UNITED STATES  
NUCLEAR REGULATORY COMMISSION  
WASHINGTON, D. C. 20555

APPLICANT: General Electric Company (GE)  
PROJECT: Advanced Boiling Water Reactor (ABWR)  
SUBJECT: SUMMARY OF MEETING HELD ON NOVEMBER 20 AND 21, 1991

Figure 10.1-1 REFERENCE STEAM & POWER CONVERSION SYSTEM

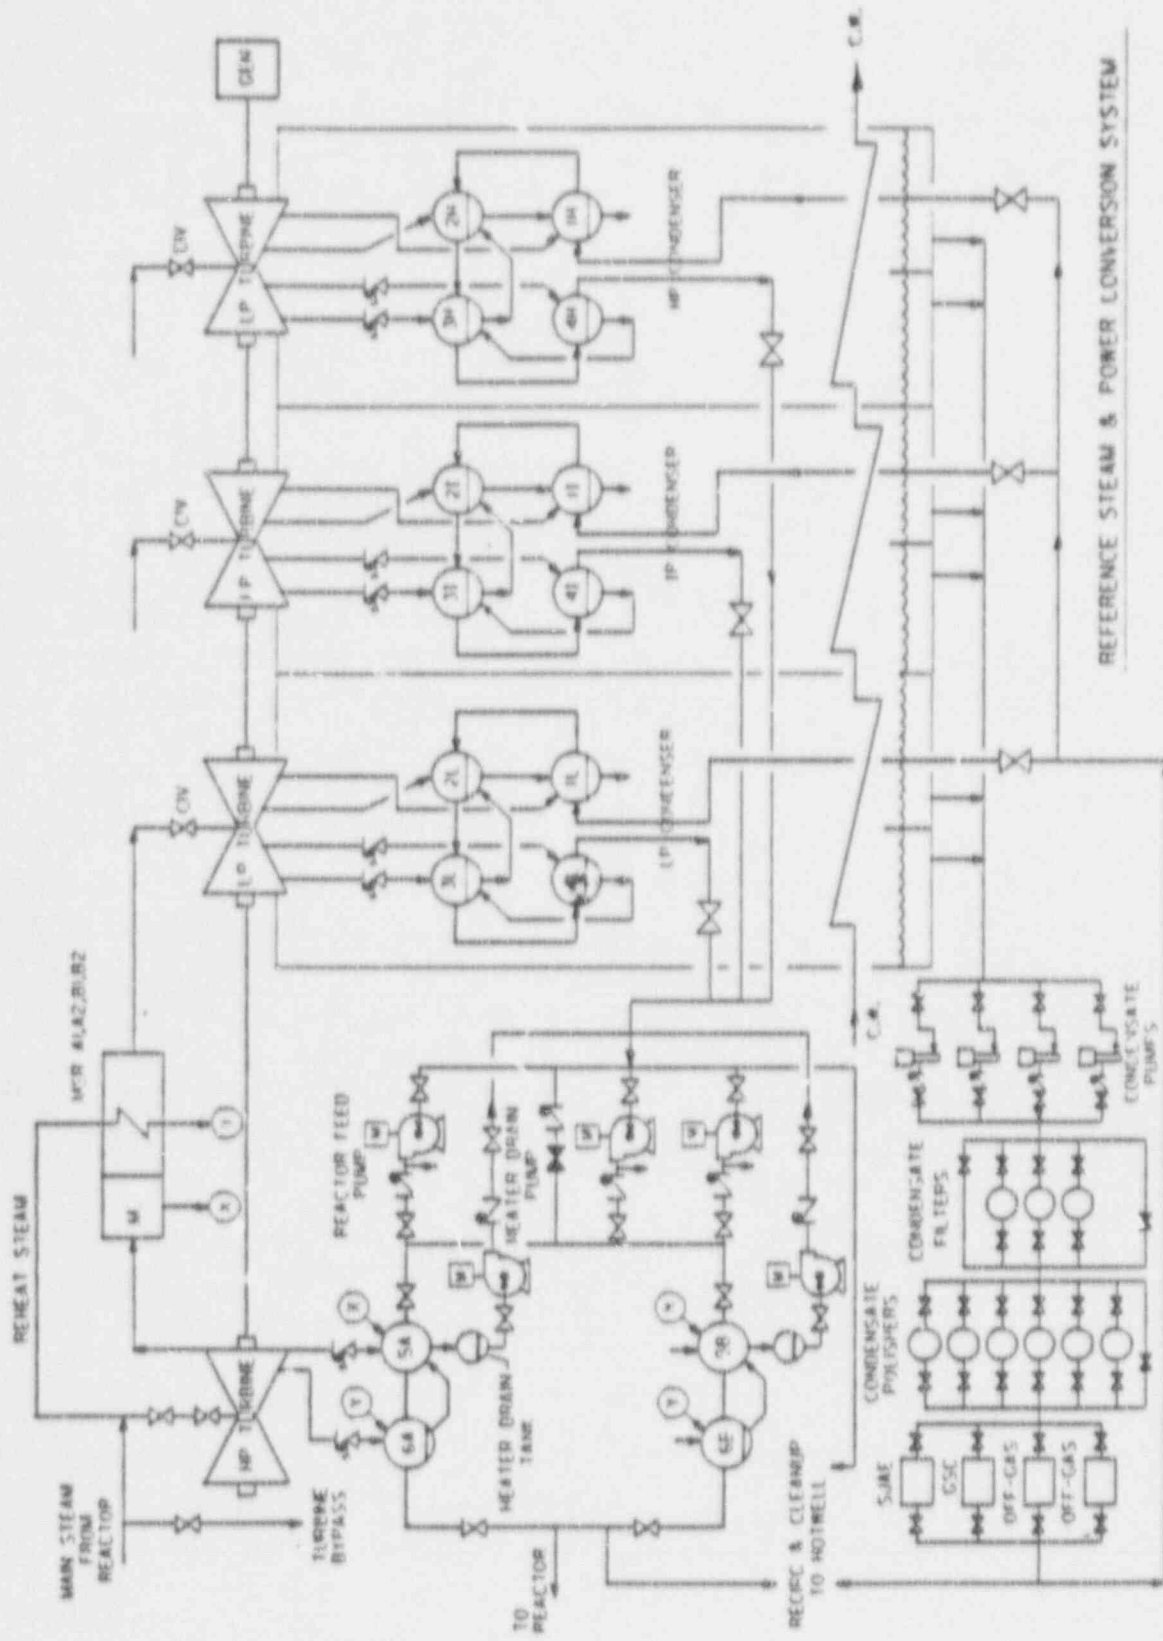
For this transient, GE assumed 100°F (55.6°C) drop in feedwater temperature. However, a drop of 150°F has occurred at a domestic Boiling Water Reactor. The staff requires that GE analyze the transient for 150°F drop of feedwater temperature, or provide justification on their choice of limiting temperature drop (15).

The reference steam and power conversion system shown in Figures 10.1-1 to 10.1-3 meets this requirement. In fact, the FW temperature drop based on the reference heat balance shown in Figure 10.1-2 is as follows:

Therefore, the use of 100 °F temperature drop in the transient analysis is conservative.

A drop of 150 °F occurred at a domestic BWR was a unique condition for that particular plant design. That unique condition will not occur in the ABWR design.

Diagram of the Pressure Control System

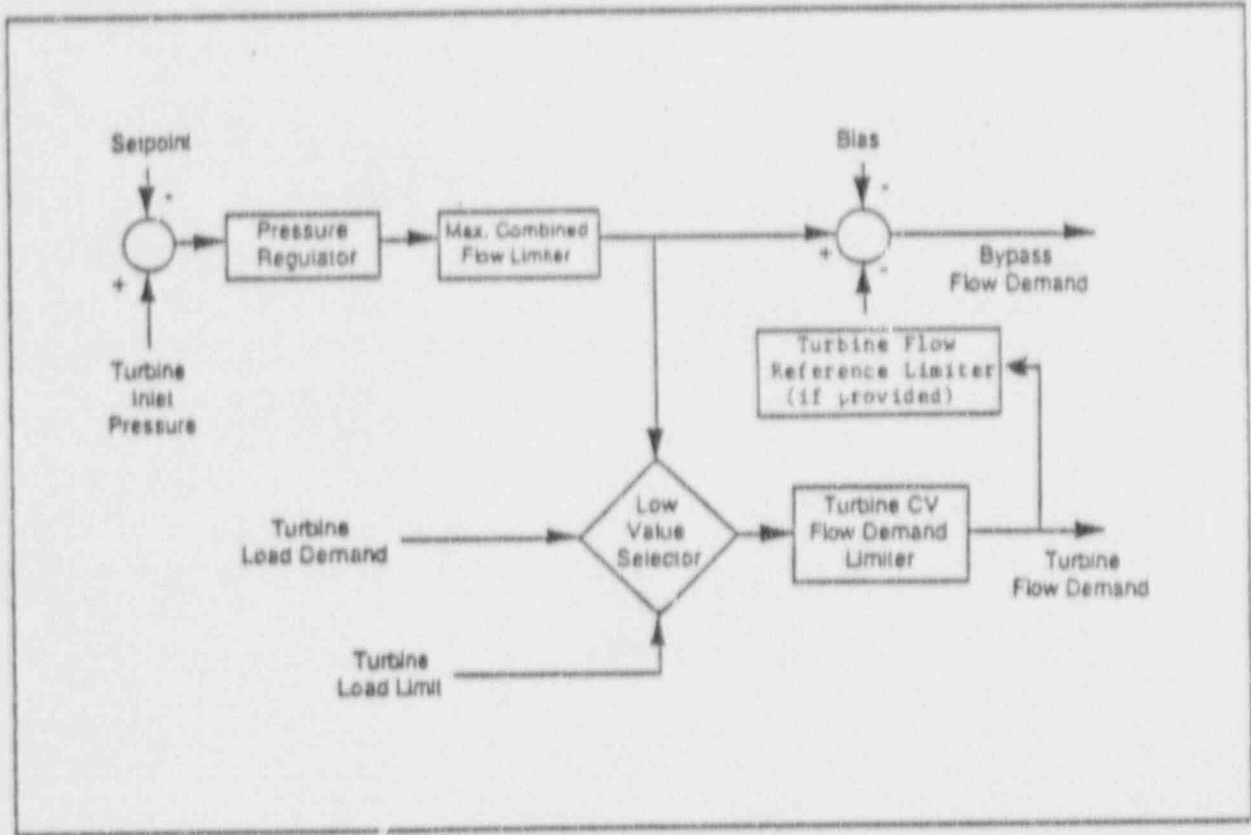
A slow turbine control valve closure causes a slow increase in reactor pressure with a corresponding slow increase in neutron flux. The reactor scram could be delayed until the high pressure scram setpoint is reached. A large increase in surface heat flux could result in large change in CPR. We require GE to analyze the slow control valve closure event for ABWR, or show that it is bounded by another moderate frequency event (15).

A single TCV closure causes an increase in reactor pressure with a corresponding increase in neutron flux. A high neutron flux scram provides quick protection with no significant change in Critical Power Ratio (CPR) for most postulated failures. However, if the postulated failure, and subsequent valve closure, occurs slowly, pressure and neutron flux increases could be such that the flux increase would not reach the high flux scram or STP scram setpoints. In this case the high reactor pressure scram would provide the remaining protection. During such a slow closure event, the remaining TCVs and bypass valves open in response to the turbine pressure control system to compensate for the steam flow reduction that results from the single TCV closure. TCVs and bypass valves open until limited by the control system limiters. A simplified diagram of a typical pressure control system is shown in Figure 1.

Because BWR/6 plants have less MCPR margin for this event than BWR/2 through BWR/5 plants, BWR/6 turbine pressure control system settings should receive additional attention. As is shown in Figure 1, steam flow for pressure control purposes is affected not only by the MCFL setting but also by other control signal adjustments or limits.

Figure 2.2.4 STANDBY MODE CONTROL SYSTEM (STANDBY MODE)

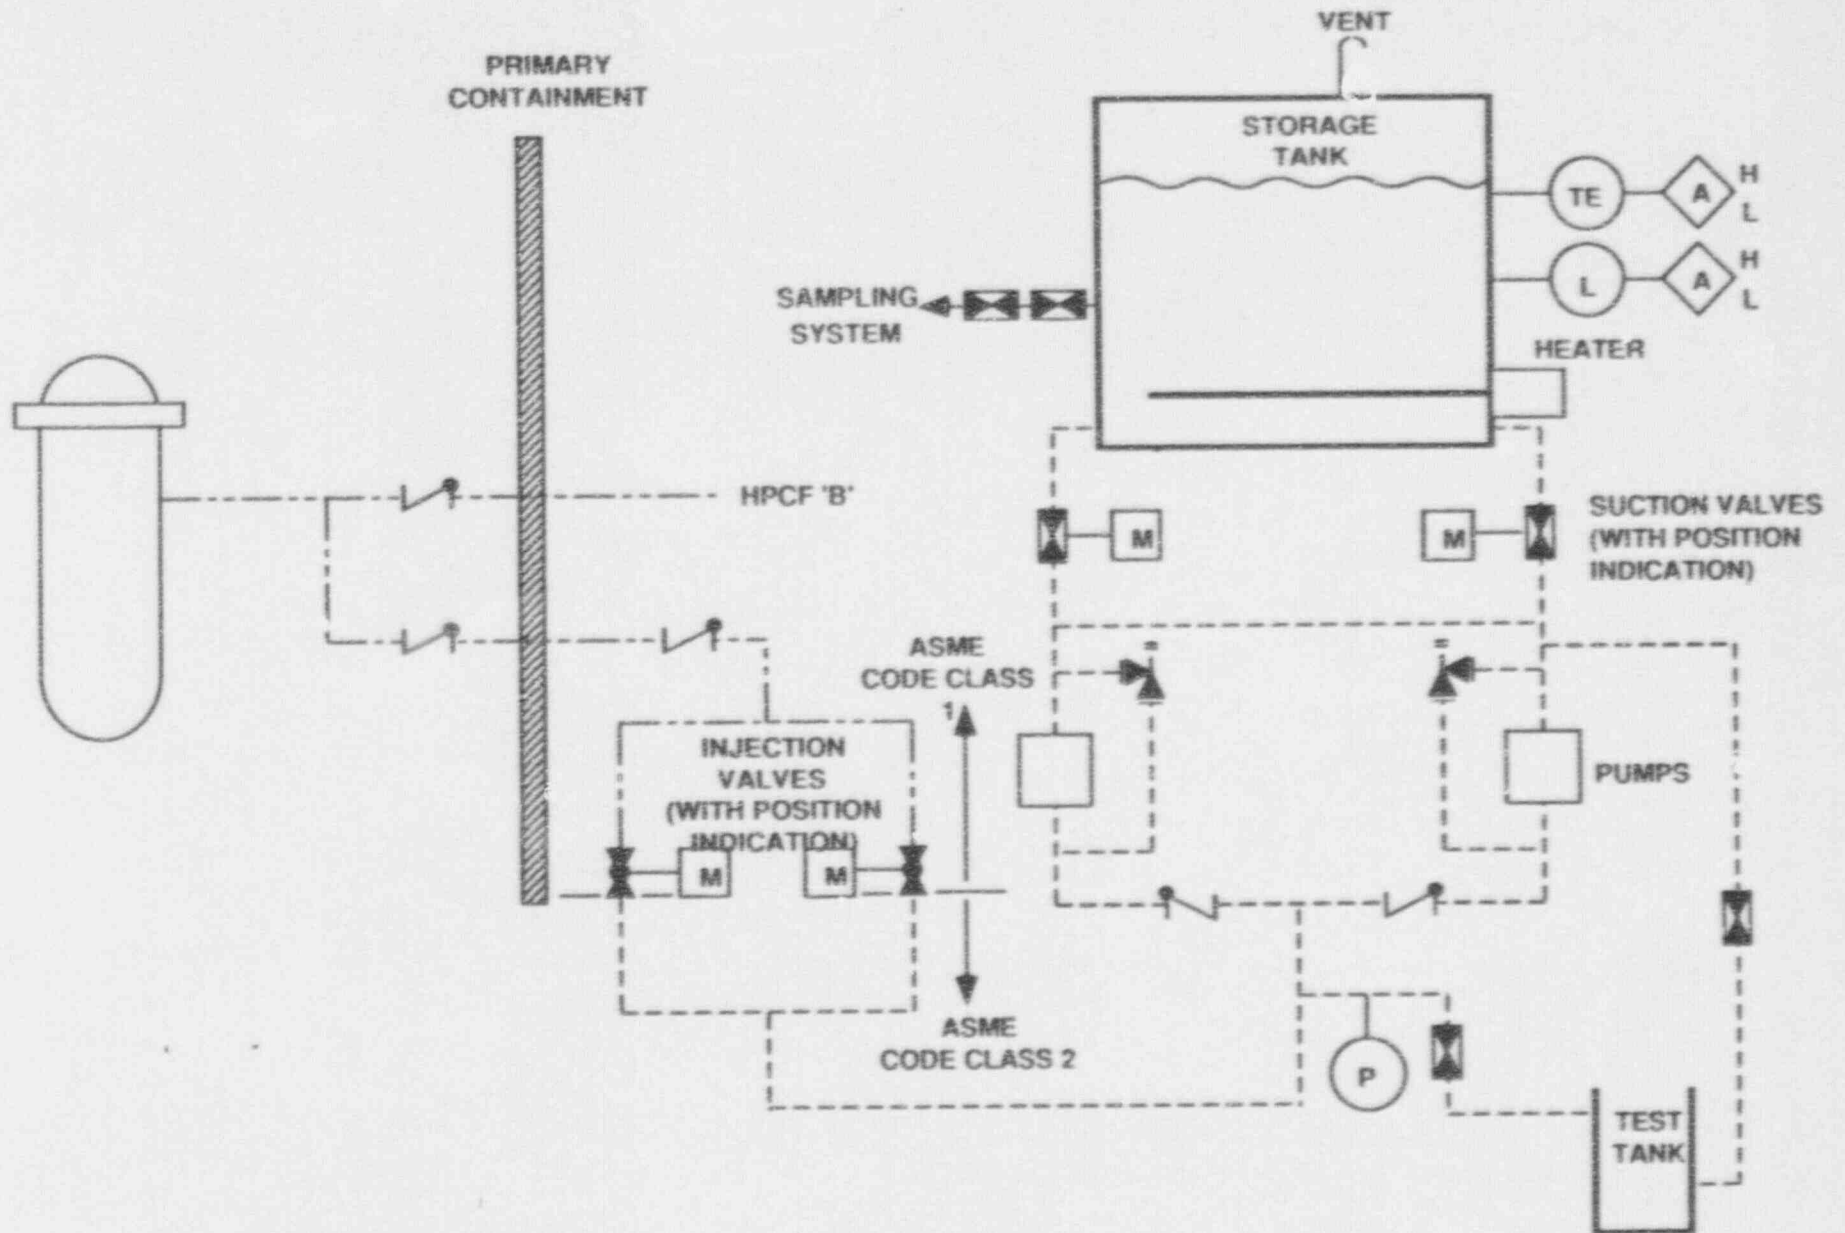
The SSAR indicates that SLCS is started manually rather than automatically as required by ATWS Rule 10 CFR 50.62 for new plants. GE has informally indicated that the SLCS design will be modified for automatic SLCS initiation. GE needs to docket this design change in a supplement to the SSAR (4.6, 9.3.5).

(3) SLCS System - GE will submit to the staff an amendment to the ABWR SSAR which indicates that the SLCS design incorporates automatic initiation.
